KENWOOD

SB-983

SERVICE BULLETIN AMATEUR RADIO

MC-48B MIC ELEMENT CHANGE

MIC ELEMENT PART # T97-1024-08

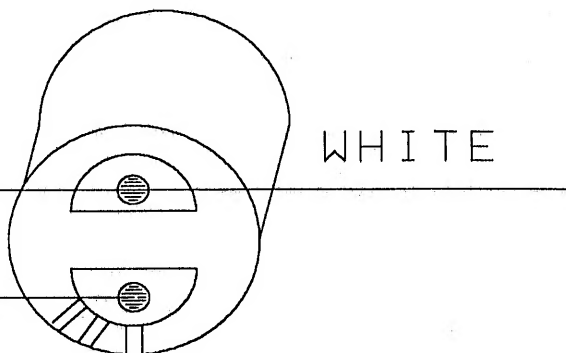
The original microphone element has been replaced. The new element has two connections and is much smaller than the original three connection element. When installing the new element, connect the wires as shown below. A 33K ohm, 1/4W resistor must be placed in series with the yellow wire. The rubber spacer is placed in front of the element when the microphone is assembled. The metal spacer can be discarded.

33K Ω
